Change Order

PROJECT: (Name and address)
Raymond Community Park
Prosper, TX

CHANGE ORDER INFORMATION:
Change Order Number: 04
Date: October 15, 2025

The Scope of Work is modified as shown in the attached DCI PCR 042A dated 22 JUL 25 and
DCI PCR 046 dated 08 SEP 25.

IRRIGATION PLAN - AREA 3

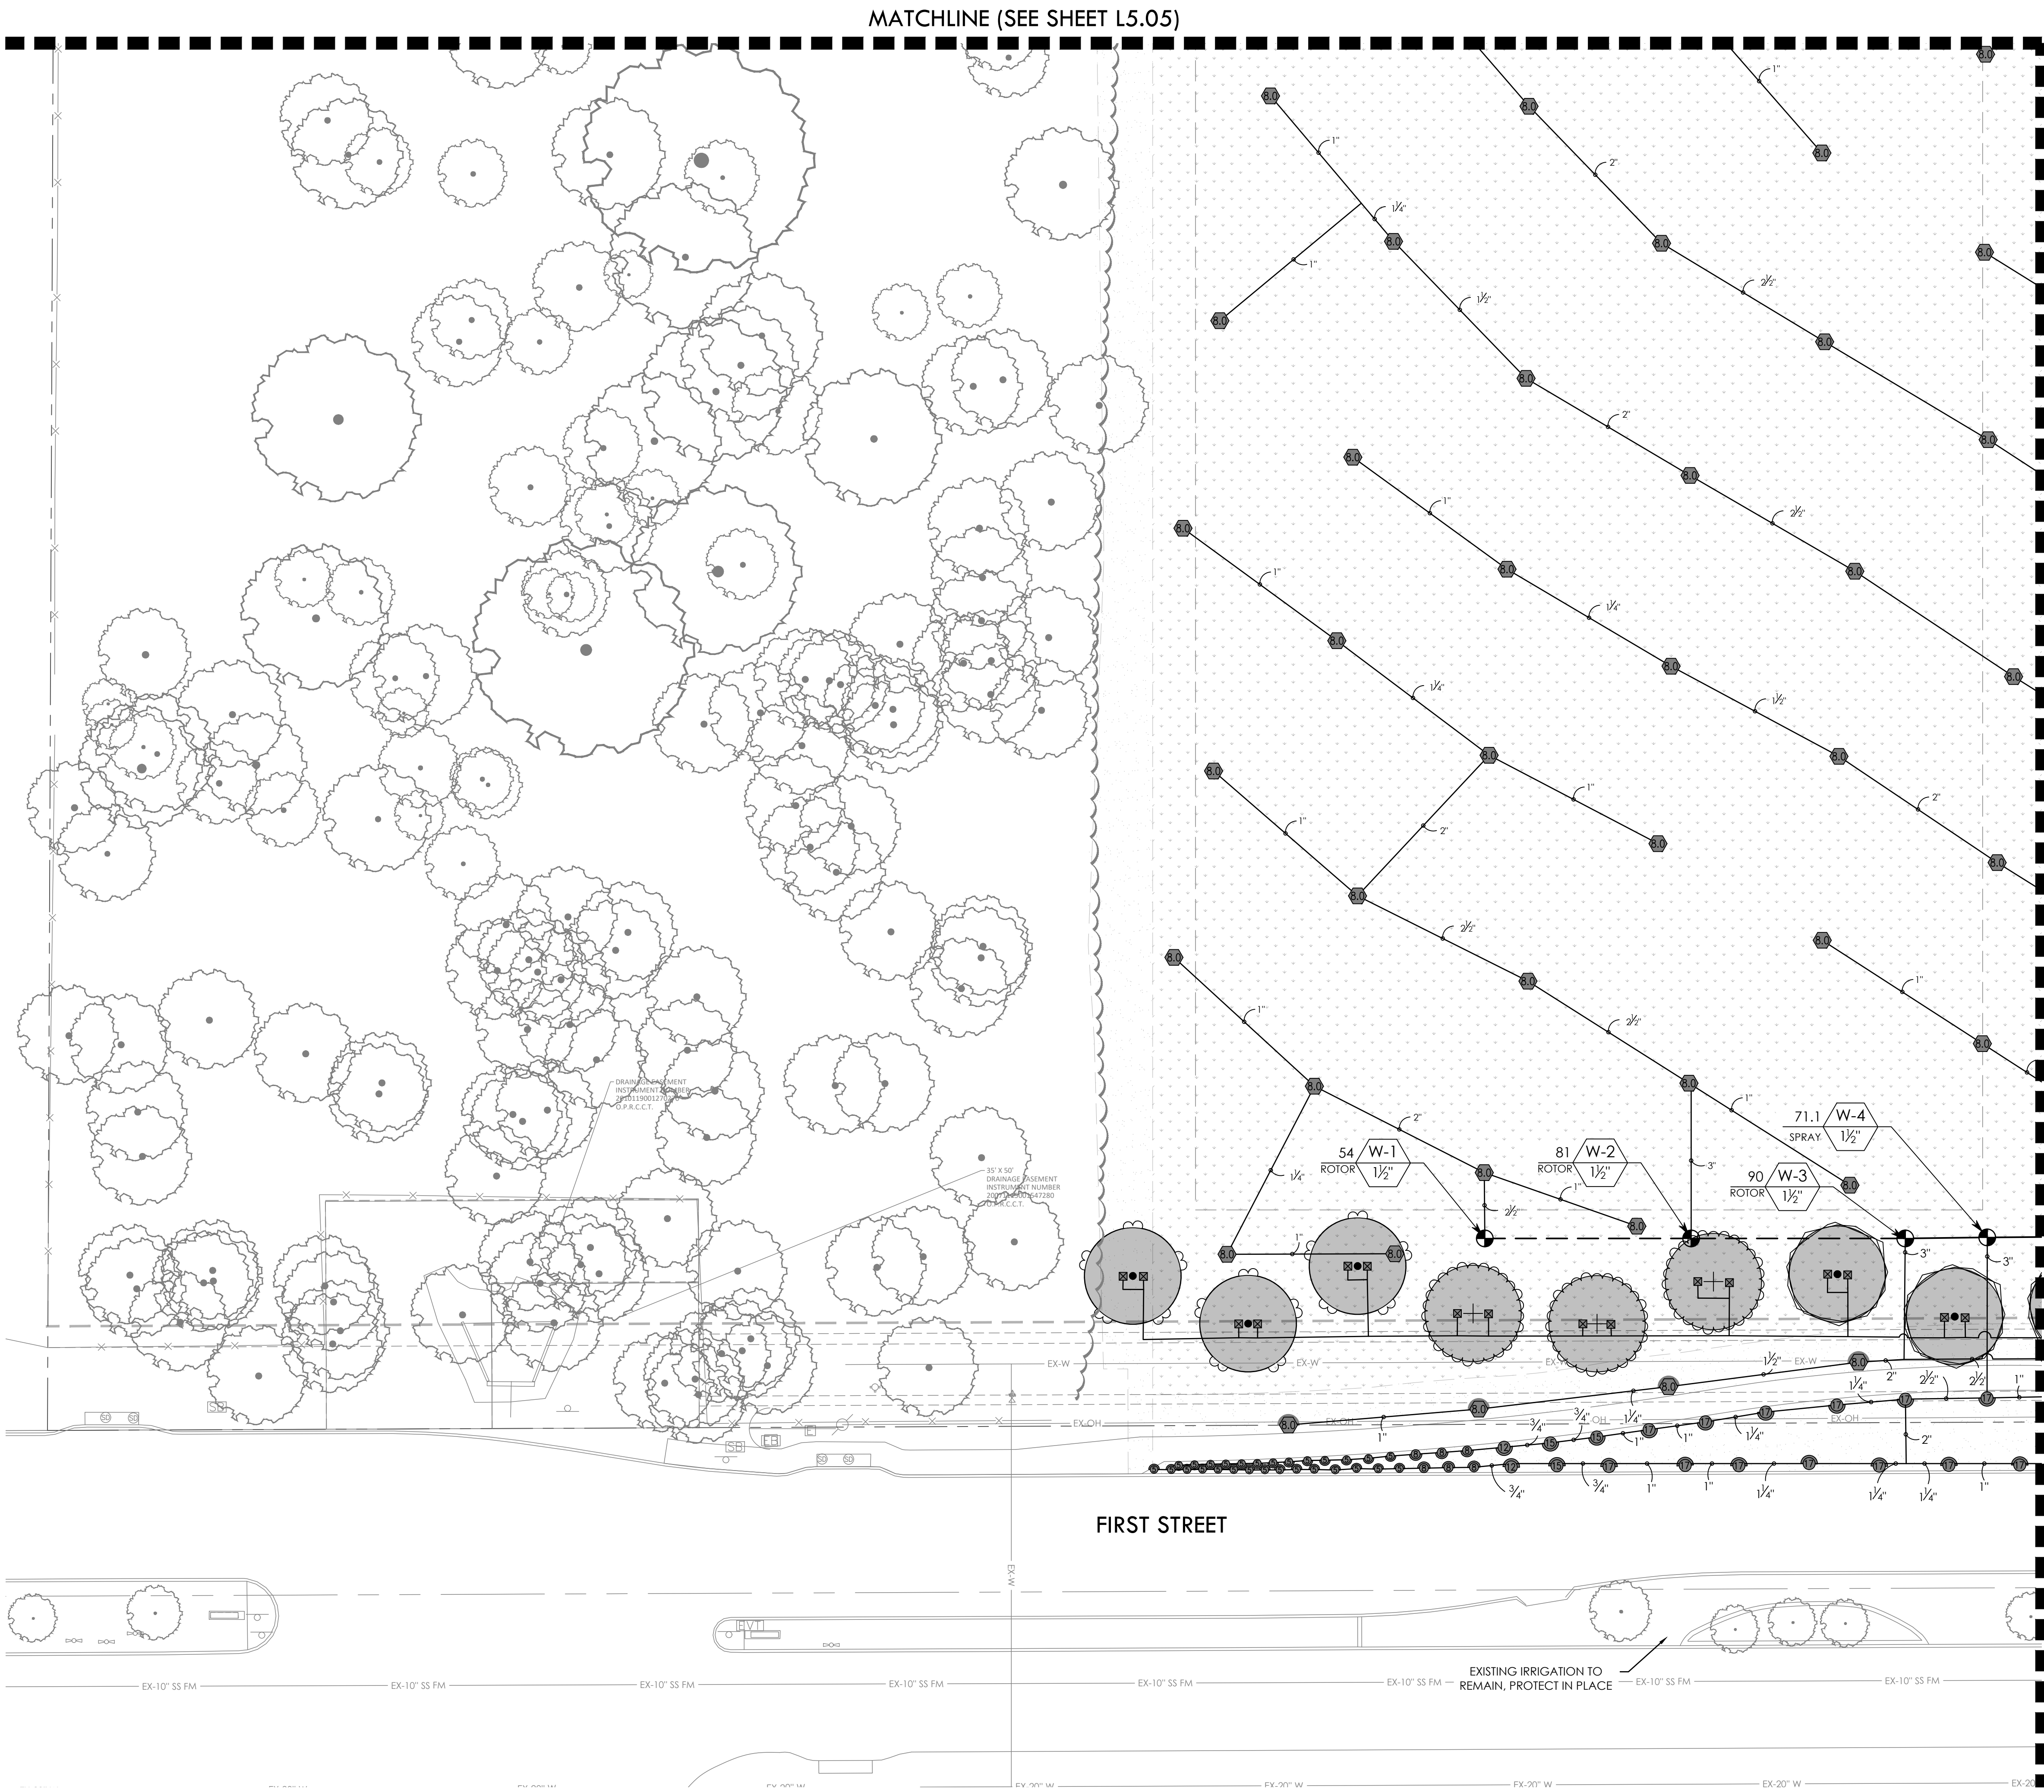
- Added note for disconnection of 4" meter
 - Show mainline disconnect in air gap valve box
4. L5.03 – Irrigation Plan – Area 3
 - Added note for disconnection of 4" meter

- Show mainline disconnect in air gap valve box
5. L5.08 – Irrigation Plan – Area 8
 - Add irrigation mainline and sleeve for new north pump location
6. L5.09 – Irrigation Plan – Area 9

IRRIGATION PLAN - AREA 10

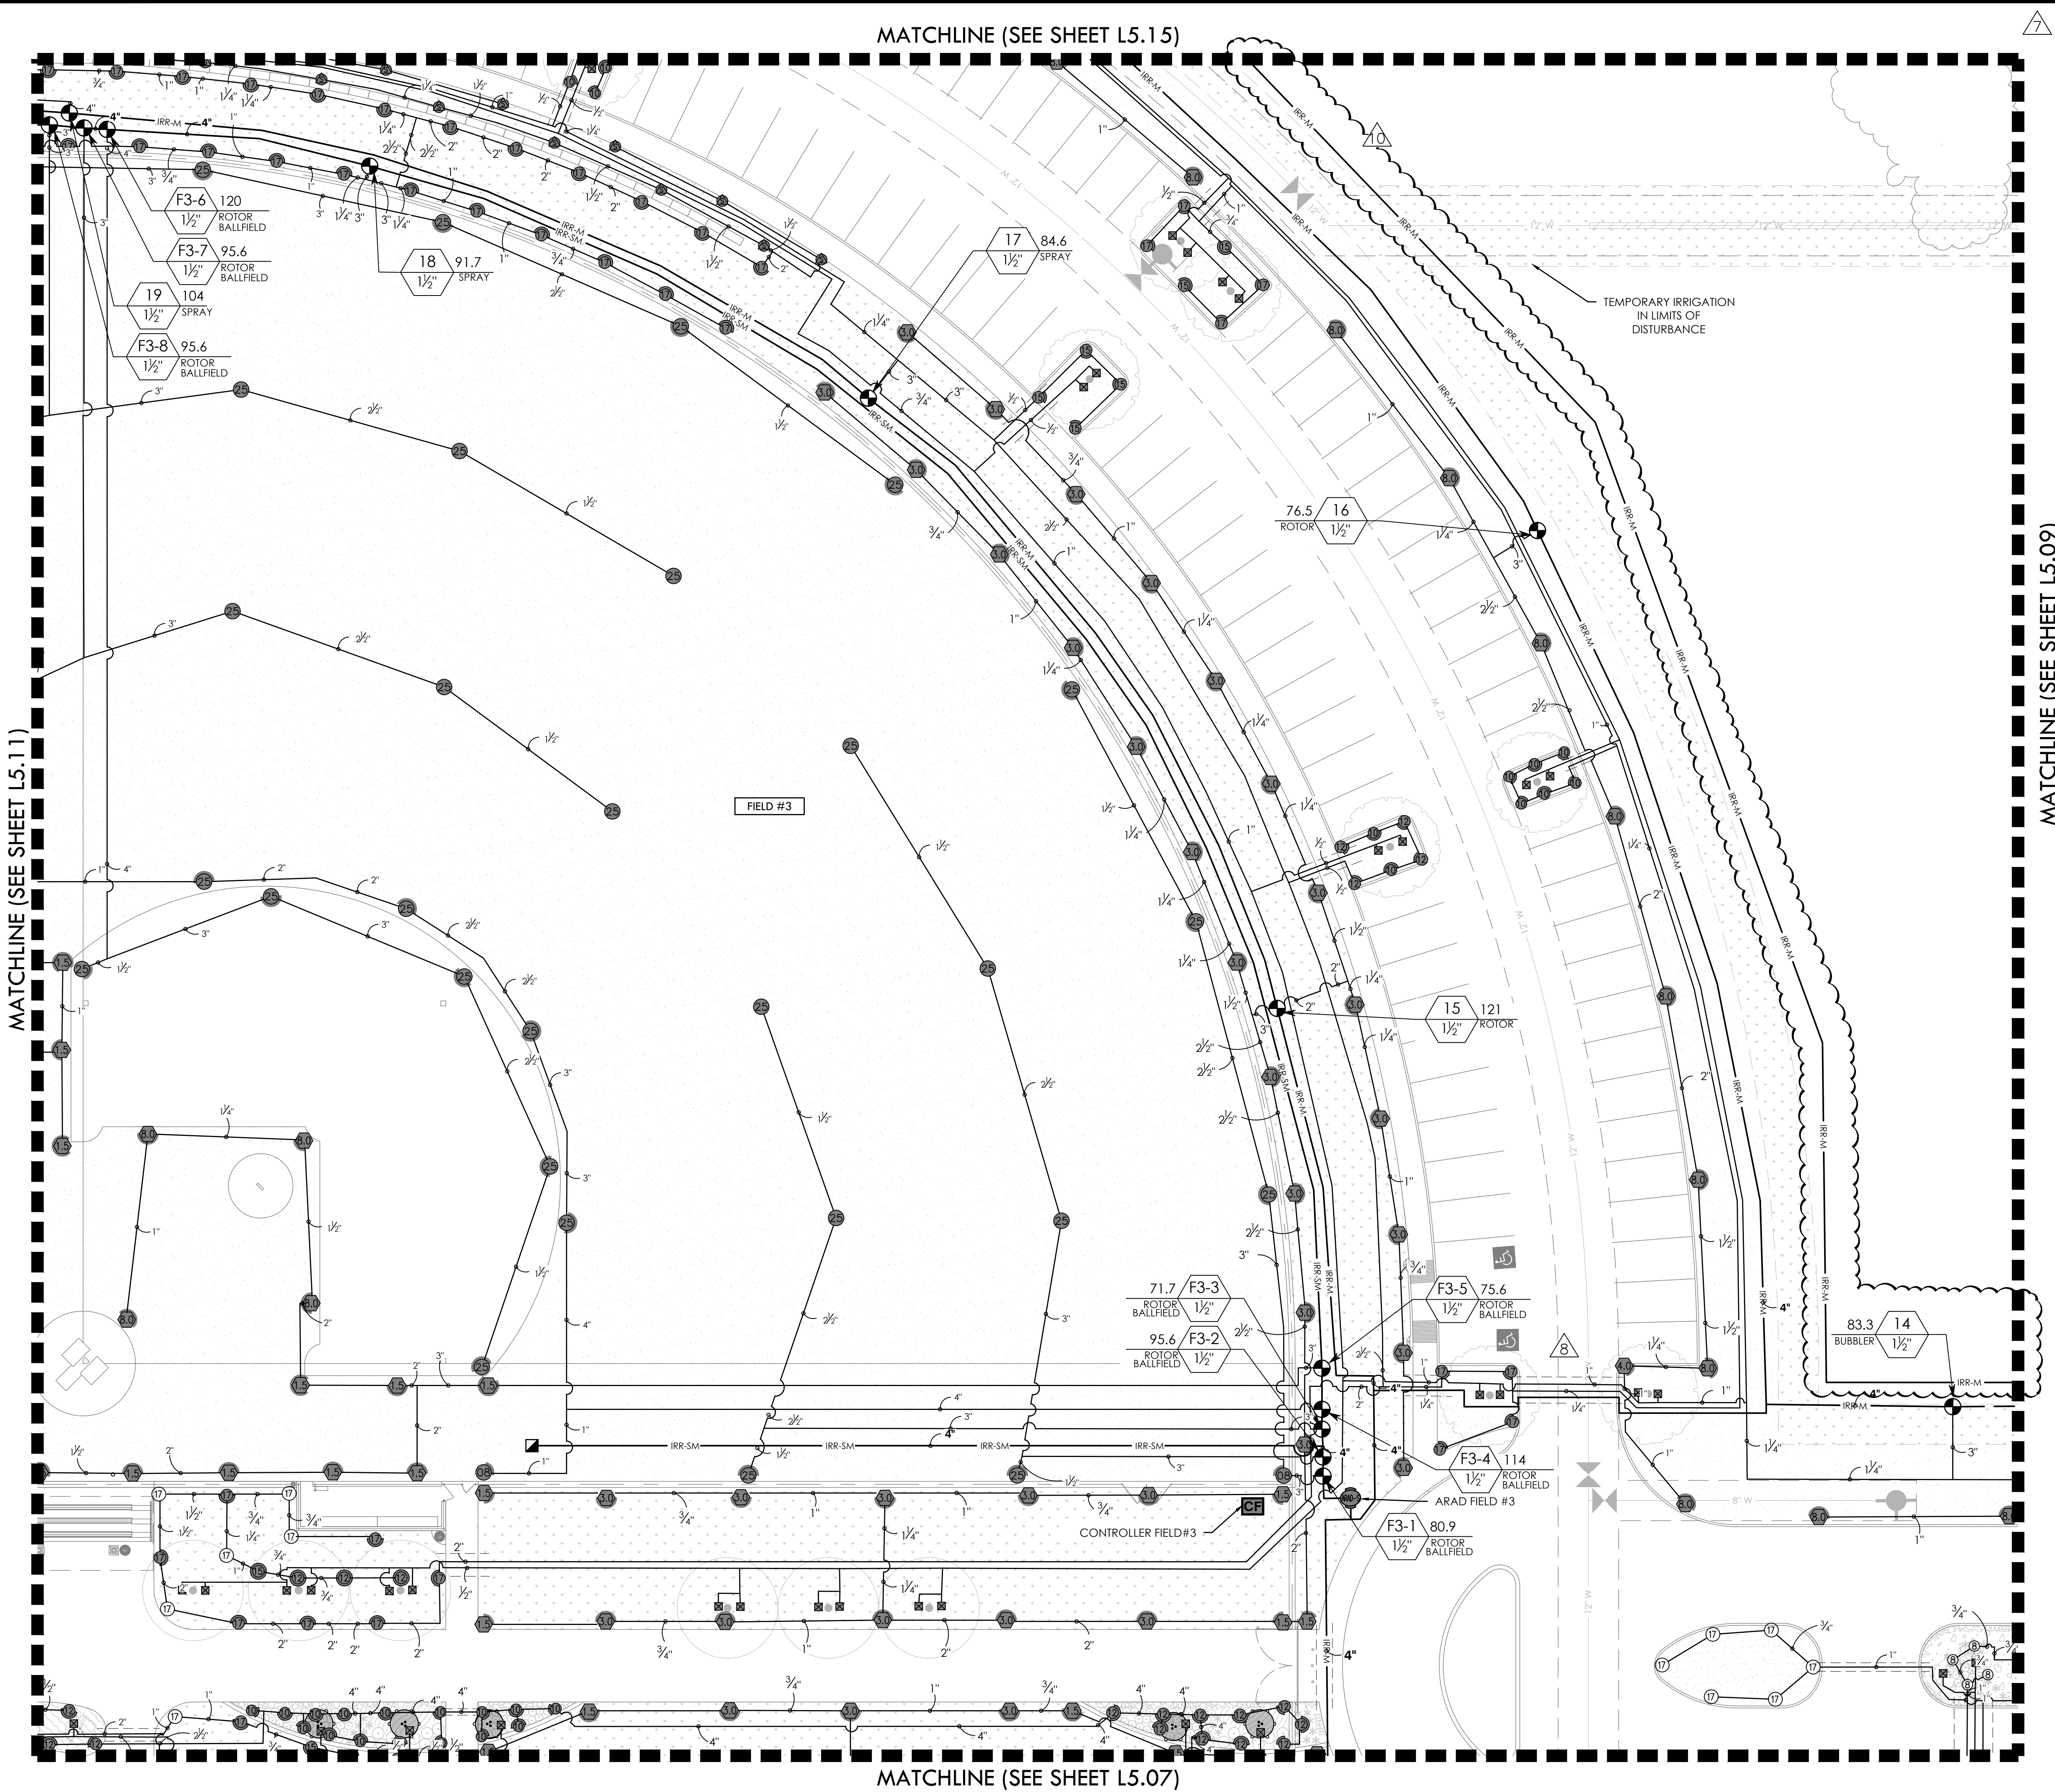
- Add irrigation mainline and sleeve for new north pump location
7. L5.10 – Irrigation Plan – Area 10
 - Add irrigation mainline for new north pump location

IRRIGATION PLAN - AREA 12

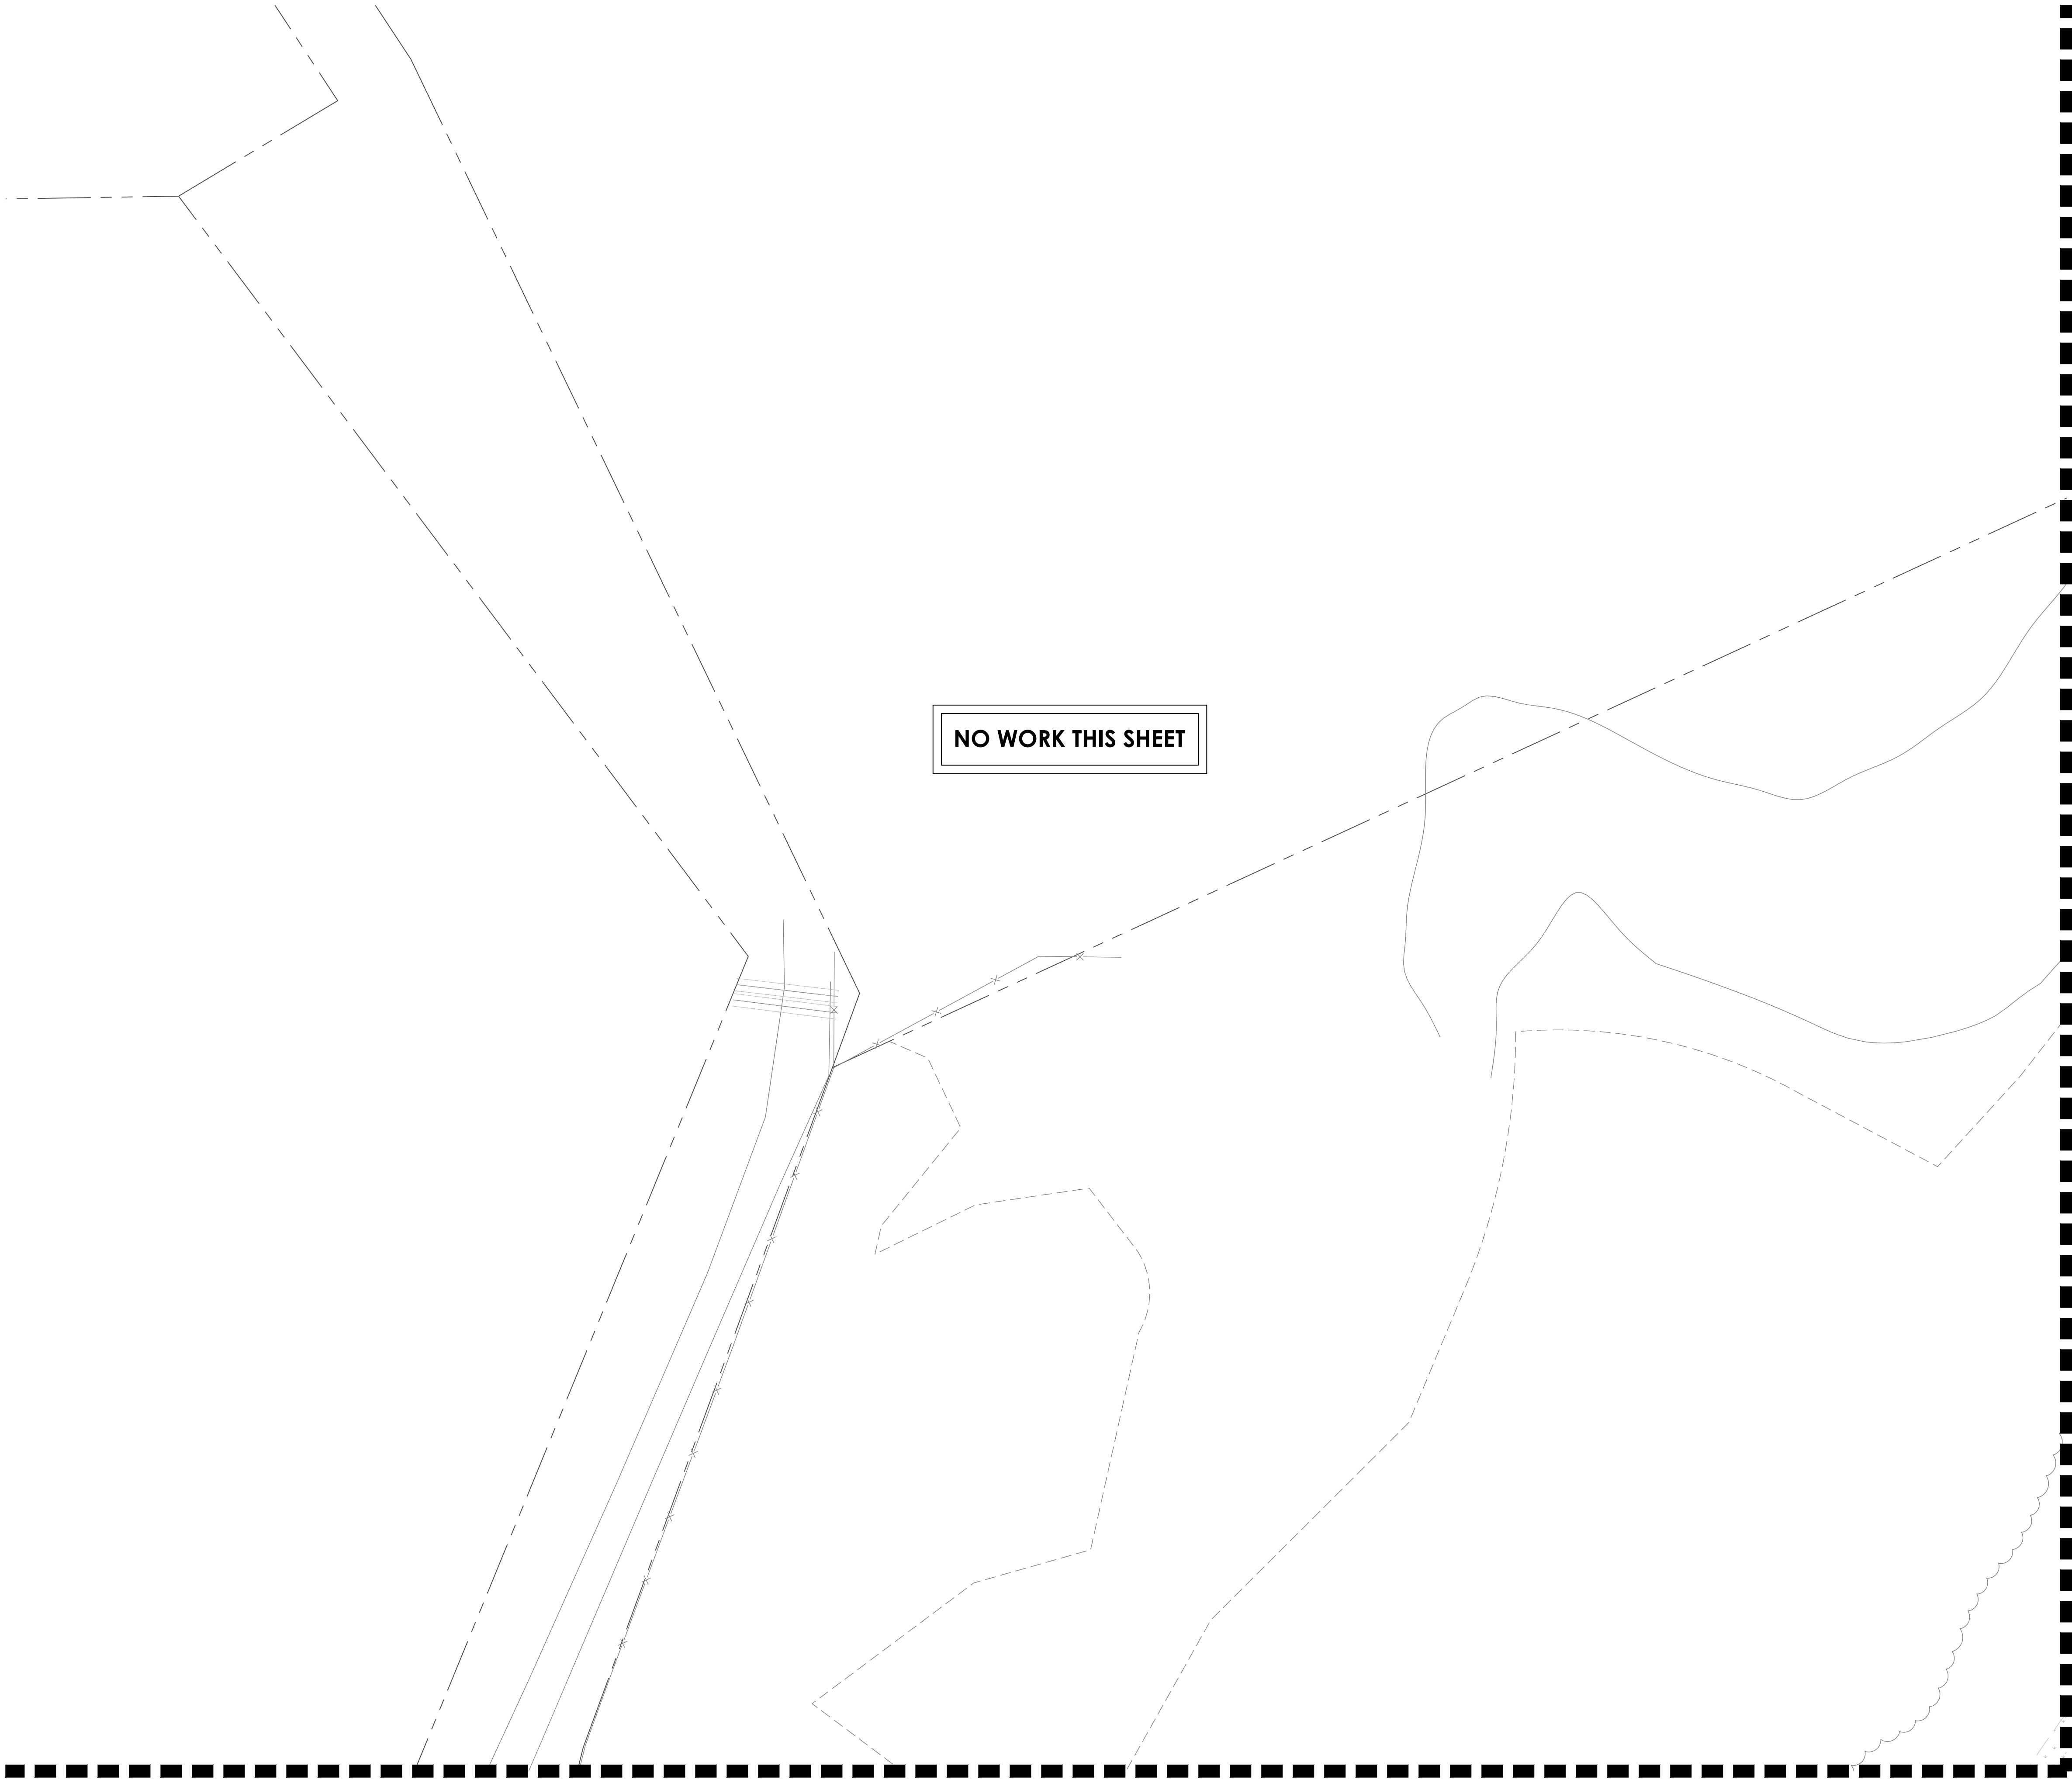
9. L5.12 - Irrigation Plan – Area 12
 - Add irrigation mainline for new north pump location
10. L5.14 – Irrigation Plan – Area 14
 - Add irrigation mainline for new north pump location
11. L5.15 – Irrigation Plan – Area 15
 - Updated viewport area to exclude pump area so that it could be shown on one whole sheet (Sheet L5.18)
 - Add irrigation mainline for new north pump location
12. L5.17 – Irrigation Plan – Area 17
 - Removed mainline that fed old pump location
13. L5.18 – Irrigation Plan – Area 18
 - Updated viewport area to include all pump/well equipment
 - Added pumps, equipment, updated locations and added/updated notes
